Case Name/ Number: PRC2021-00010/ Thompson

# PLT2021-00043

## PLT - Subdivision

Sheet 1 of 2

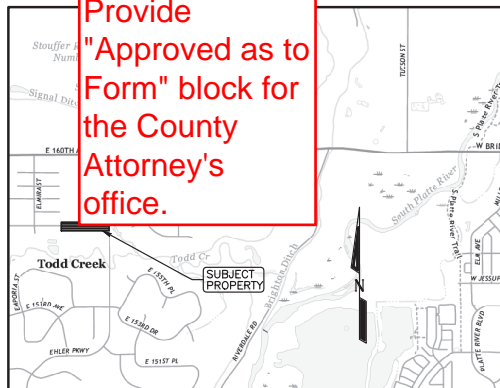
Need to provide the limits of this  
easement. If dedicated by plat,  
can vacate by plat. If dedicated  
by separate instrument, will  
need to be vacated by separate  
instrument. This will be verified  
by Title Commitment

"CHAIR" only

Provide  
"Approved as to  
Form" block for  
the County  
Attorney's  
office.

REVISED. SEE ALSO MATT  
SURA MEMO ON EASEMENT  
VACATION

REVISED

REVISED

Sheet 2 of 2

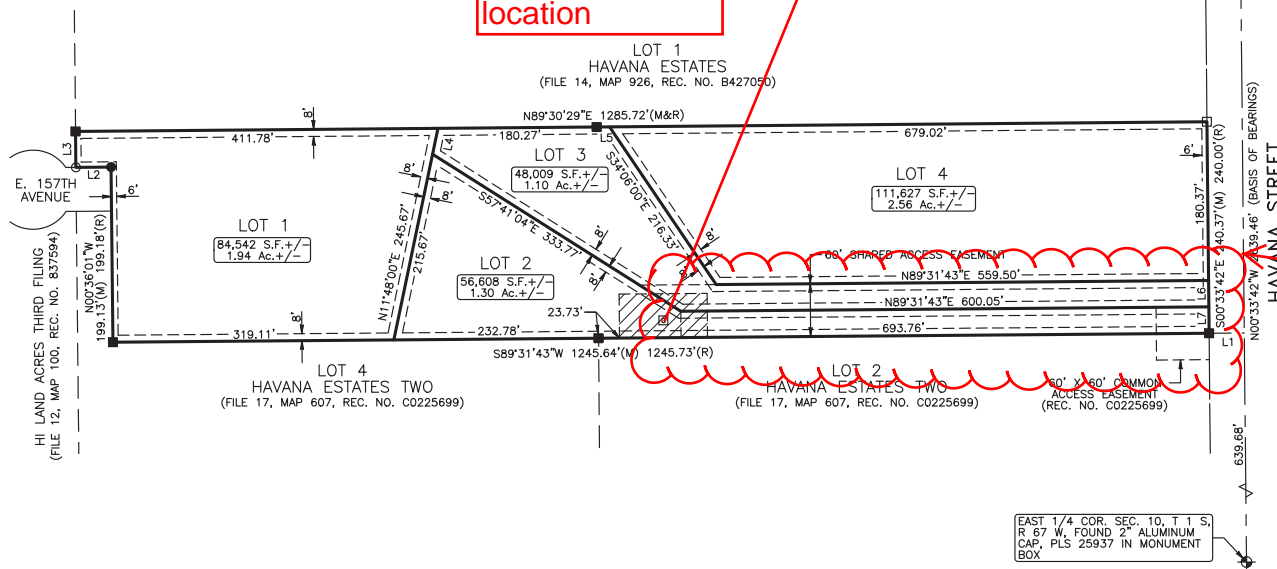
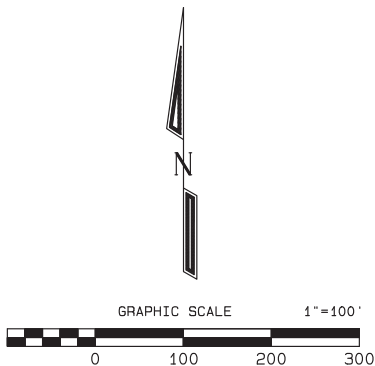
Need POC and  
 POB for newly  
 created legal

Provide oil and  
 gas easement  
 notes and  
 location

SEE PLAT NOTE 8

POC ADDED. POB NOT  
 ADDED DUE TO NO  
 METES & BOUNDS  
 REQUIRED.

SEE REVISED PLAT NOTES
